PERMIT CARD

742 E. WATERBURY RD

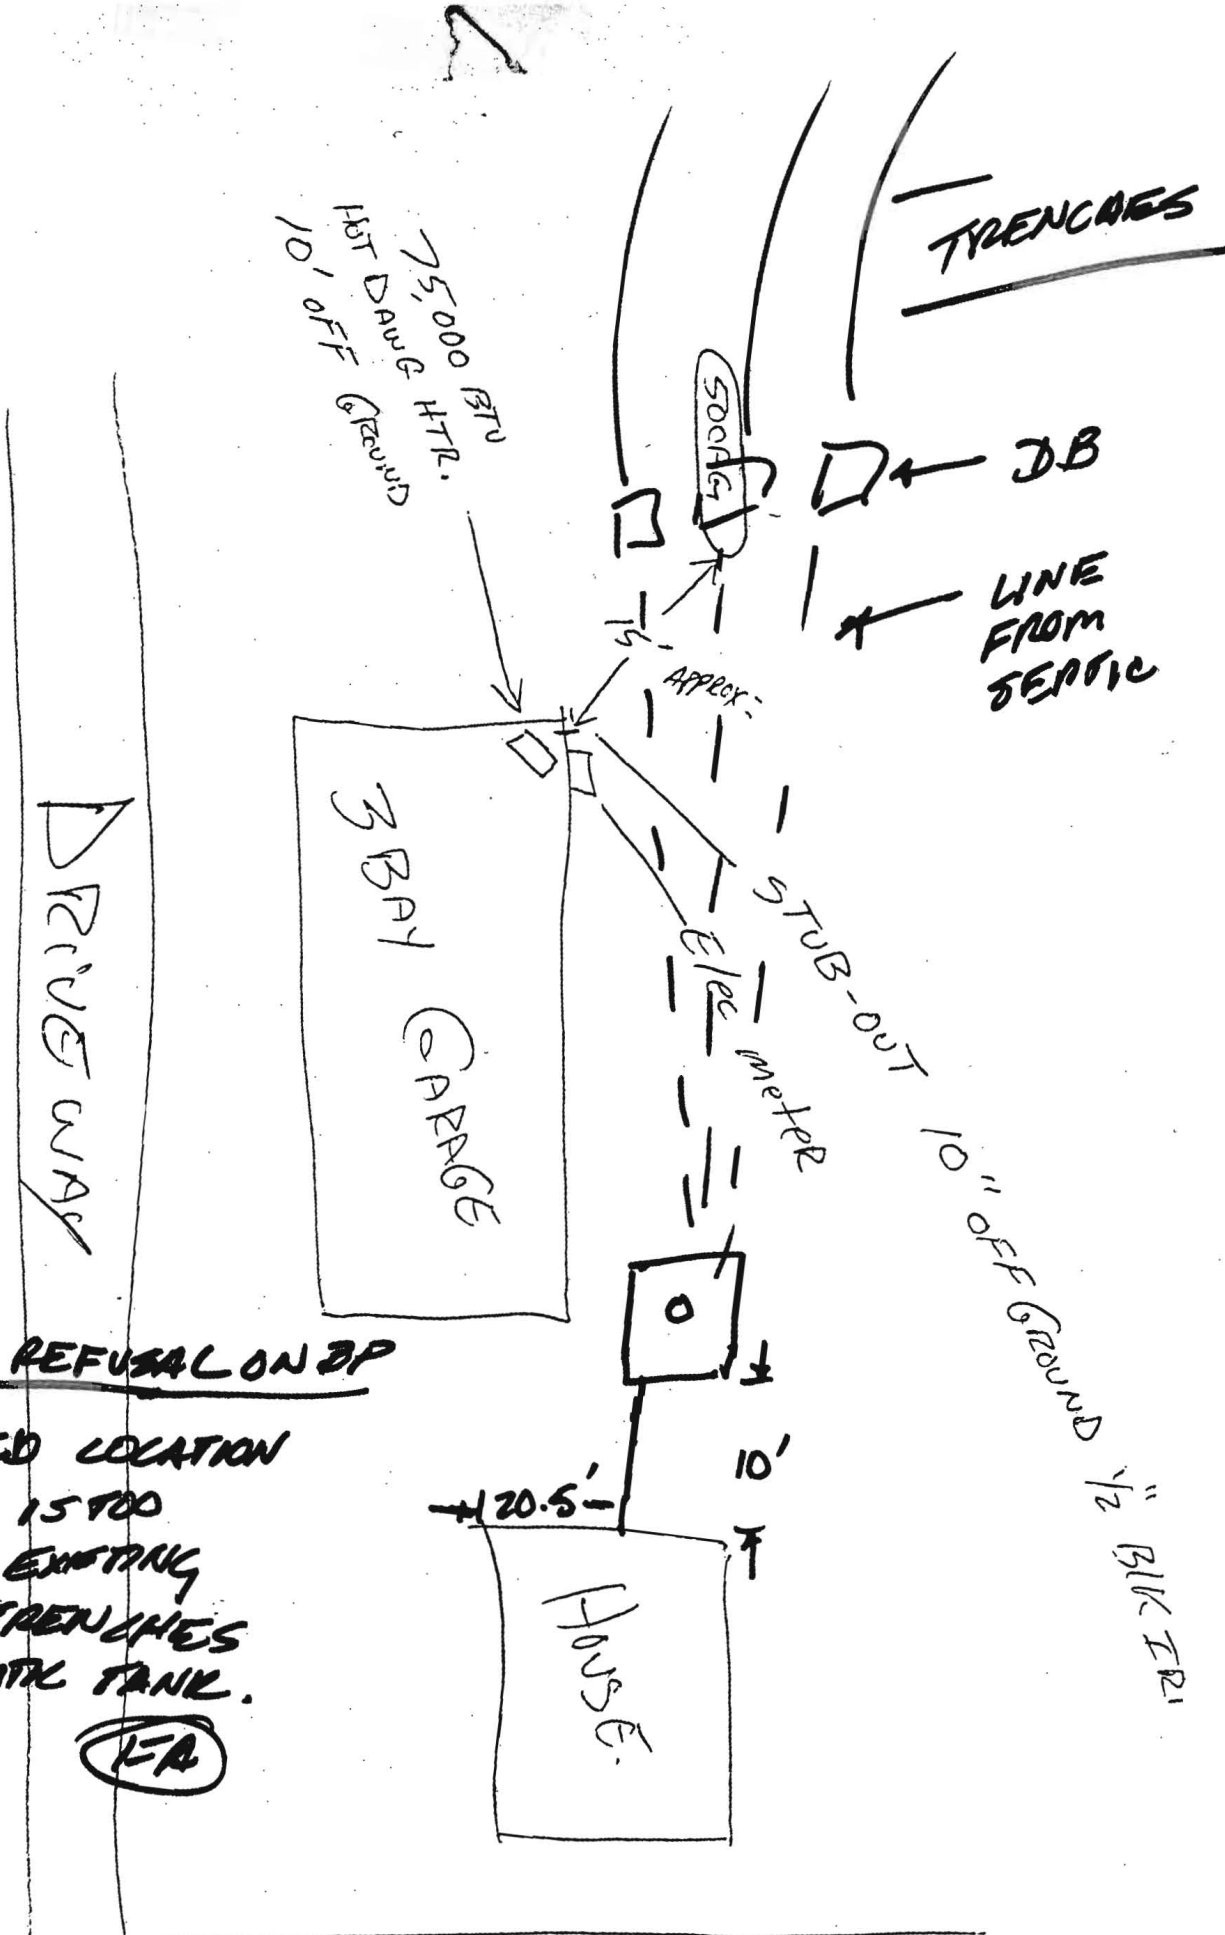
REMARKS: 5-10-85 - WORK DONE TO TRENCH #1 OK TO COVER PIPE FROM ST TO DB. FOR ACCESS TO TRENCH #1 SA

5-10-85 OK TO COVER ALL WORK

9/11/03 - Line to new garage installed OK to cover 50

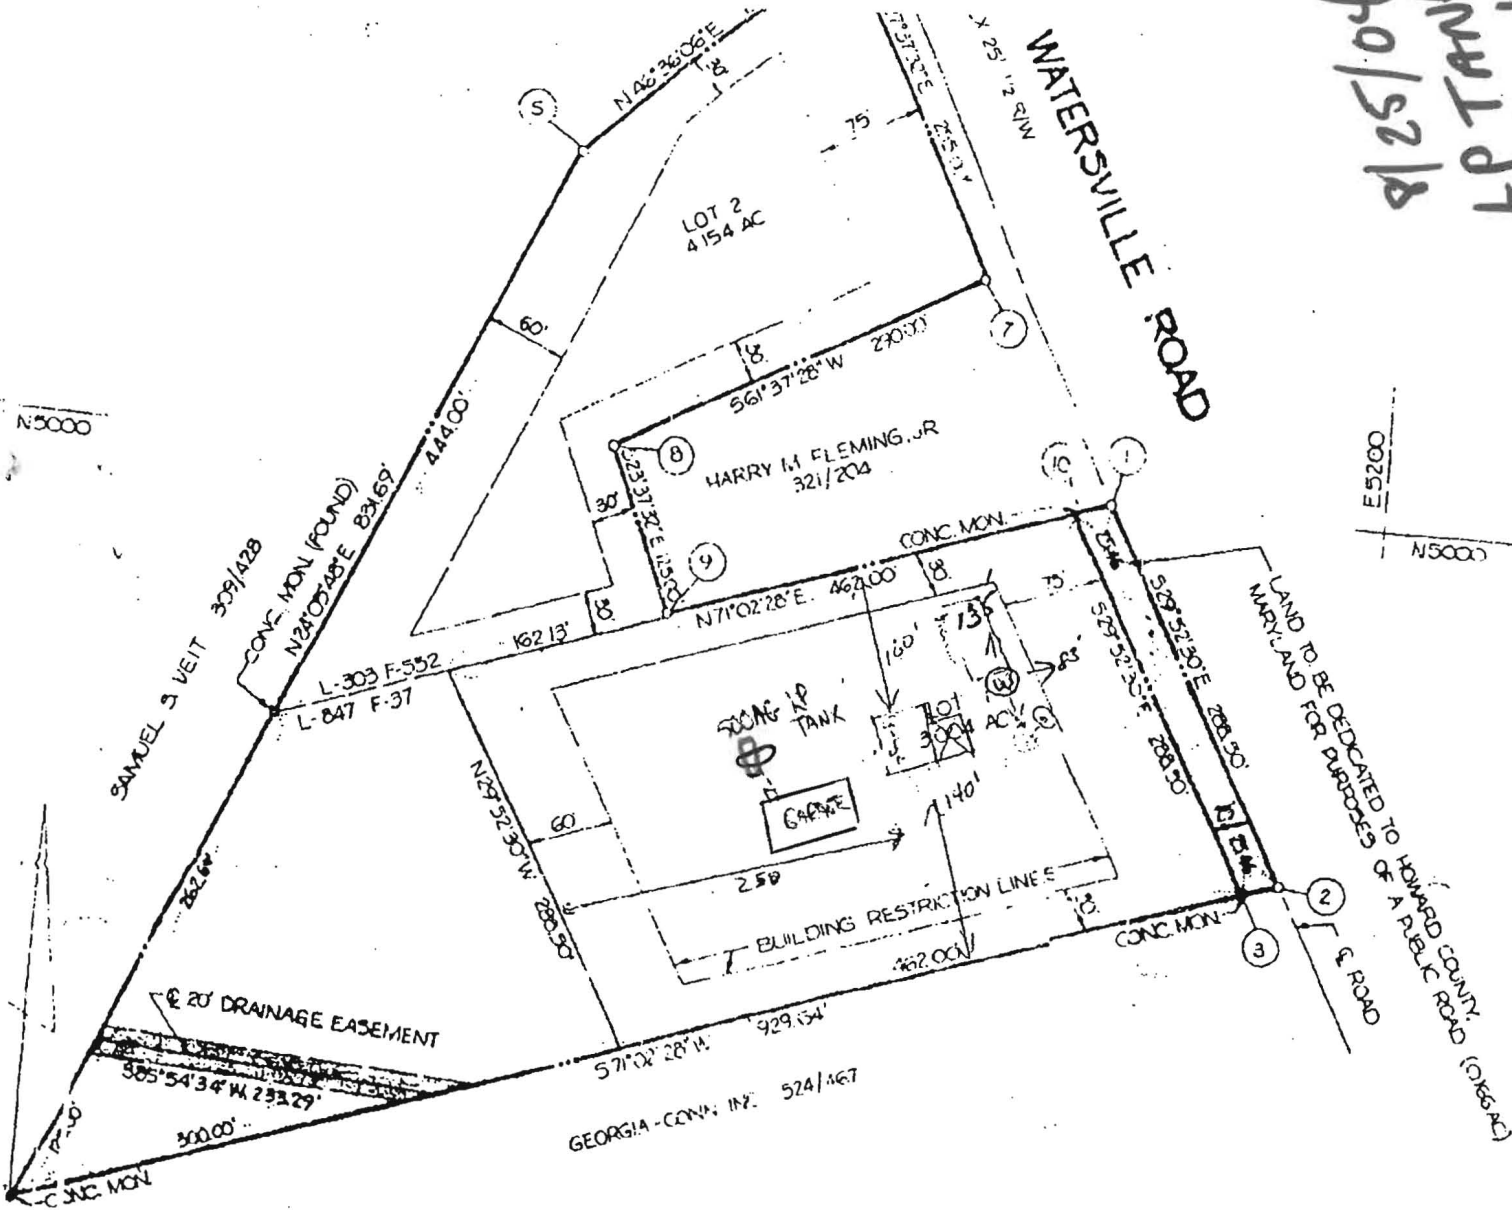
REASON FOR REFUSAL ON DP

* PROPOSED LOCATION OF TANK IS TOO CLOSE TO EXISTING SEPTIC TRENCHES DB & SEPTIC TANK.

8/25/04
 LP TANK NOT
 RELOCATED.

Above
 Ground -
 Completely
 visible, however,
 permit not
 approved due
 to loc KN

5-28-04
 PROPOSED LP Tank not
 buried however, placed
 per plan. location is
 over septic line (KN)
 Relocate LP per
 SB's request
